SUBJECT: Forwards response to IE Bulletin 79-27 re electrical buses
 powering safety-related & nonsafety-related instrumentation
 & control circuitry. Info suppls util 851104 response.

Re: Nine Mile Point Unit 2
Docket No. 50-410

2VBB-UPS1C TEST SUMMARY

ENGINEERING DESIGN CHANGE NEL-350 1/90

PARTIAL OF EXIDE DRAWING.
D 110 615 235

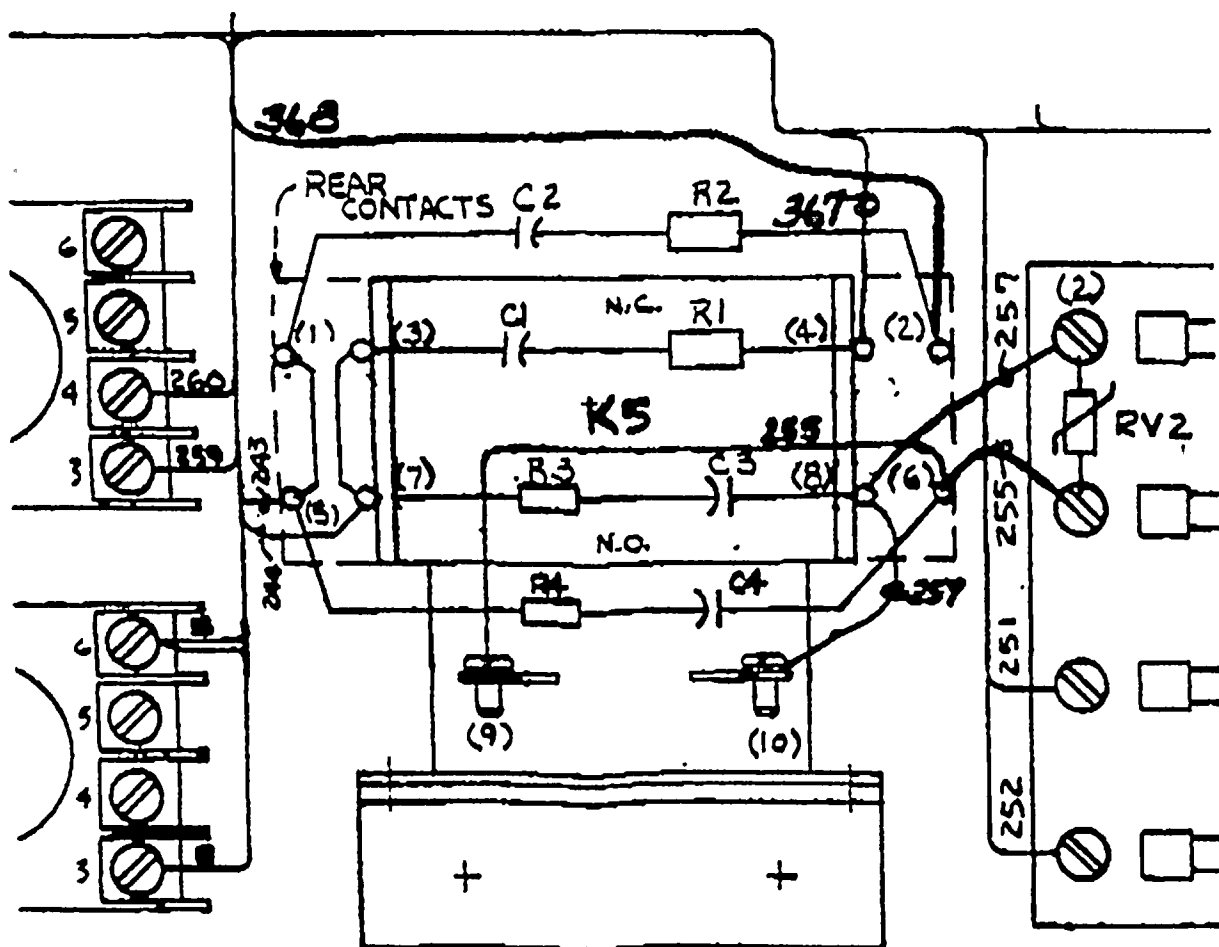
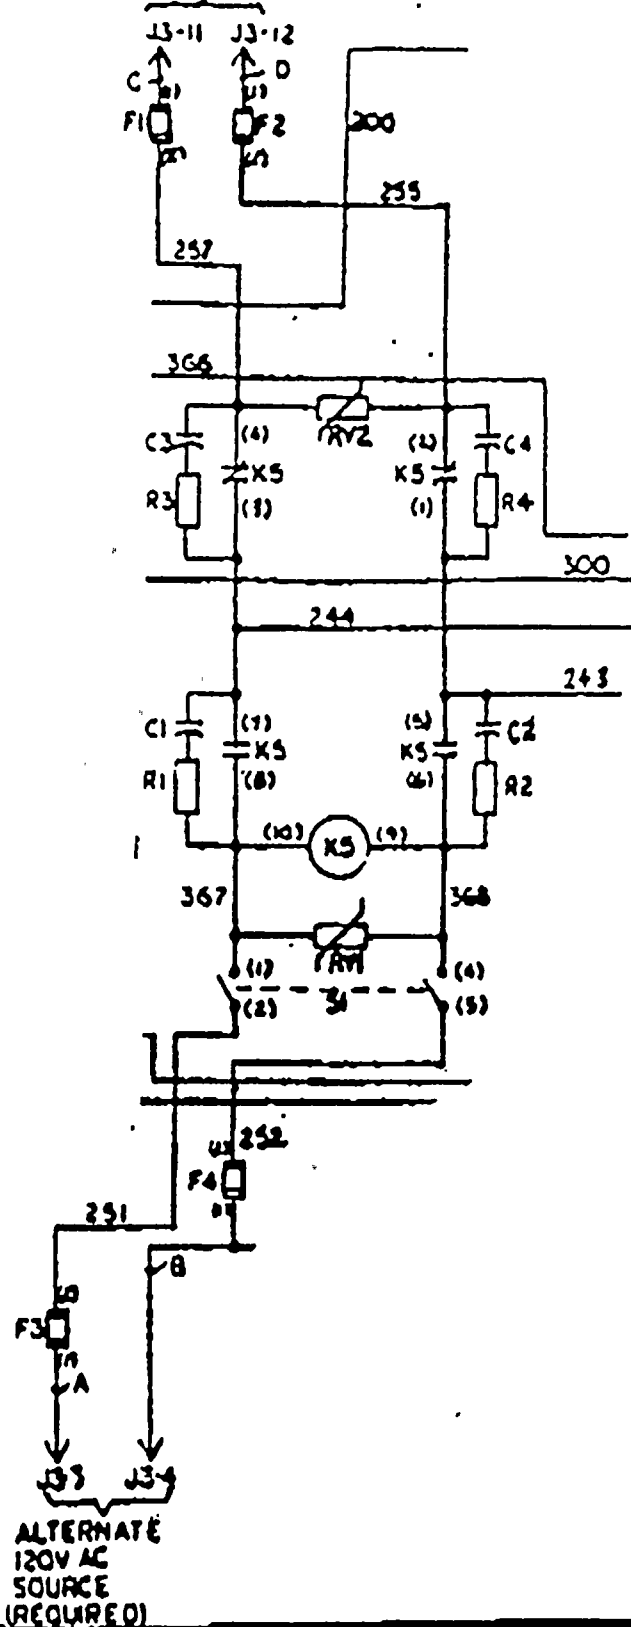
EXIDE INSTRUCTIONS:**REF: NIAGARA MOHAWK****CHANGE RECOMMENDATION TO A27 PANS**

- 1) TRANSFER LOAD TO BYPASS
- 2) SECURE CB4
- 3) SHUT DOWN MODULE
- 4) REMOVE PAN A27
- 5) RELOCATE RVI FROM RELAY K5 PIN(9) - (10)
TO SWITCH S1 PIN (1) - (4)
- 6) DISCONNECT WIRE # 368 FROM K5(9) -
- 7) DISCONNECT WIRE # 367 FROM K5(10)
- 8) DISCONNECT WIRE # 257 FROM K5(4) -
- 9) DISCONNECT WIRE # 255 FROM K5(2) -
- 10) RECONNECT WIRE # 368 TO K5(2) -
- 11) RECONNECT WIRE # 367 TO K5(4)
- 12) RECONNECT WIRE # 257 TO K5(8) -
- 13) RECONNECT WIRE # 255 TO K5(6) -

- 14) RENAME JUMPER K5(8) TO K5(10)
FROM 367 TO BE 257
- 15) RENAME JUMPER K5(6) TO K5(9)
FROM 368 TO 255 —
- 16) REPLACE CONTROL BATTERY BANK WITH NEW ONES
- 17) REMOUNT A27
- 18) RESUME NORMAL UPS OPERATION.

TO:
NMPC NO: N2E356001PW/SUP001
PG. C110 6/1334

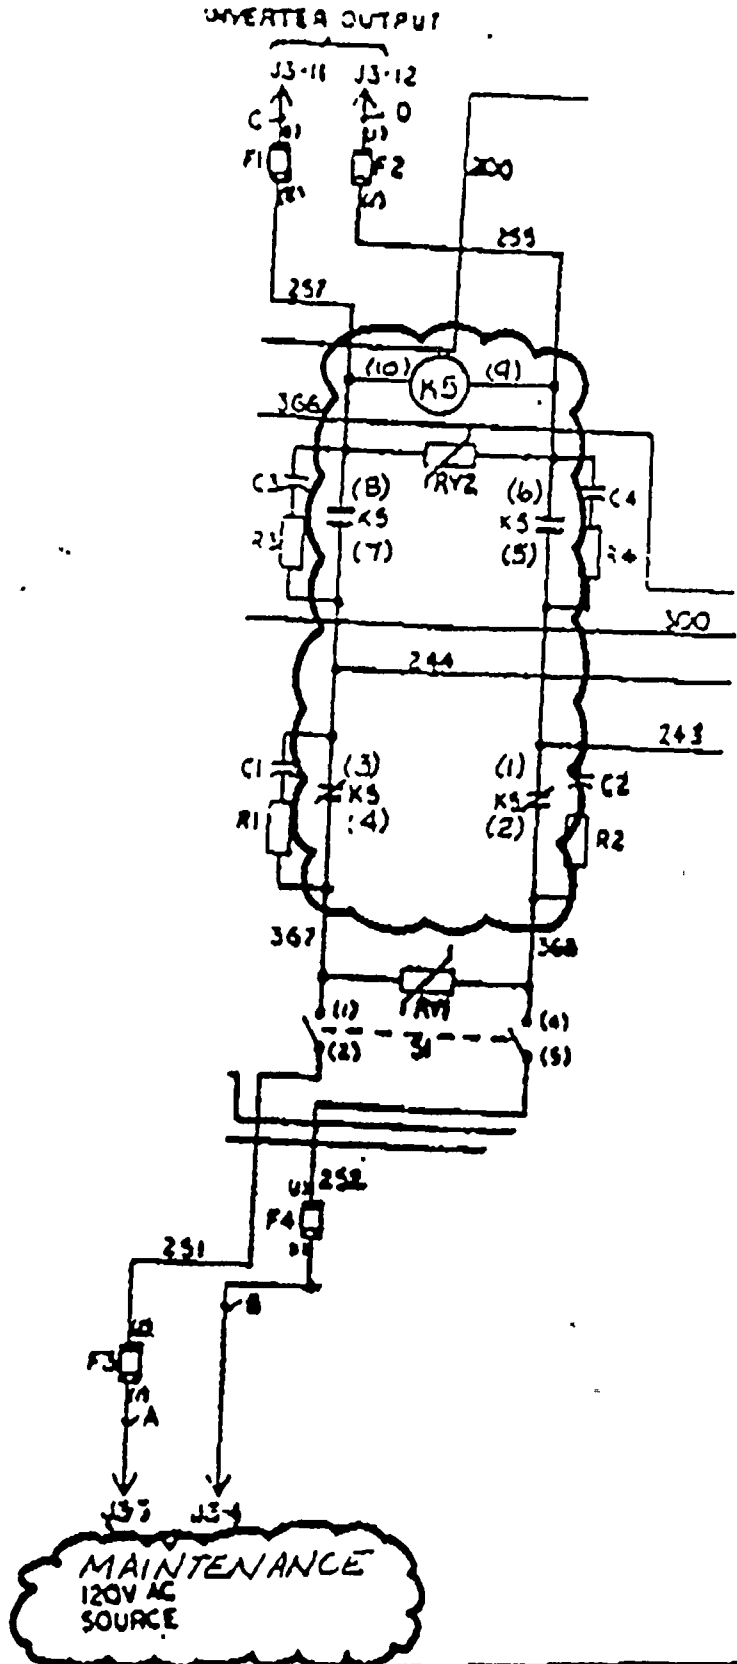
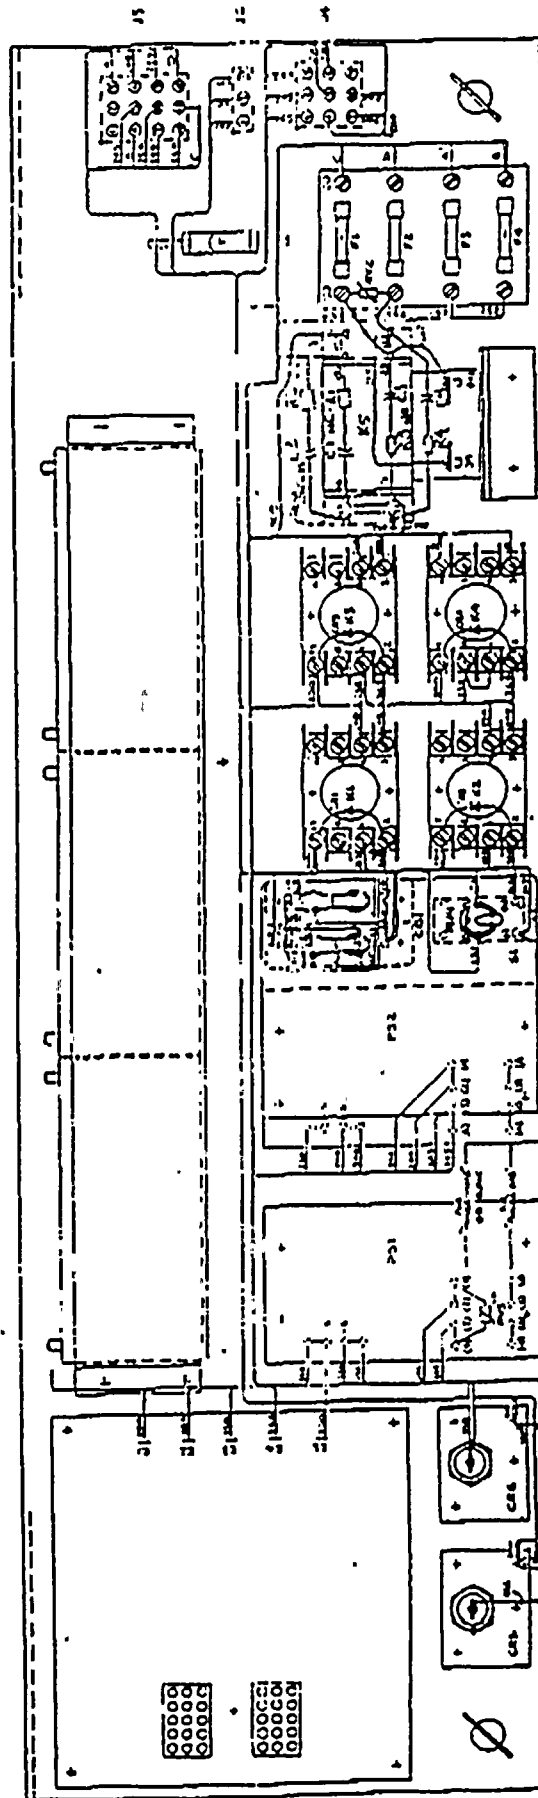
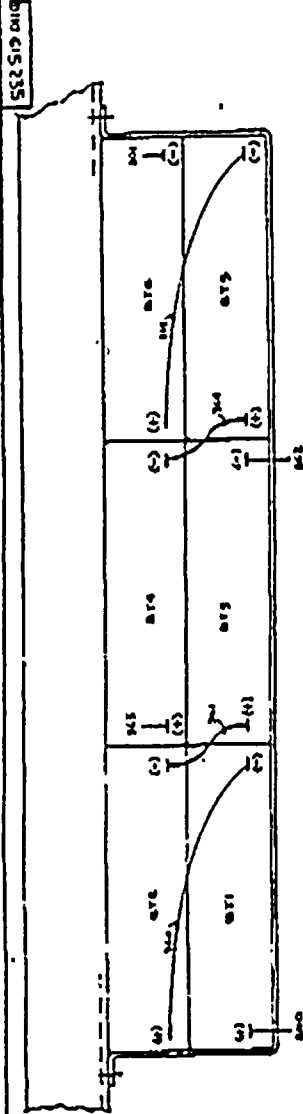
ADD TO NMPEN0:
NZE356001PWSUPPOOL
IN SECTION 3

ADD TO NMPCNO:
 N2E35600IPWSUP001
 IN LIST OF DRAWINGS PAGE 0-5

REVISE NMPCNO:
 N2E35600IPWSUP001
 SECTION 2.3.7 ON PAGES 2-10 and 2-11
 AS FOLLOWS:
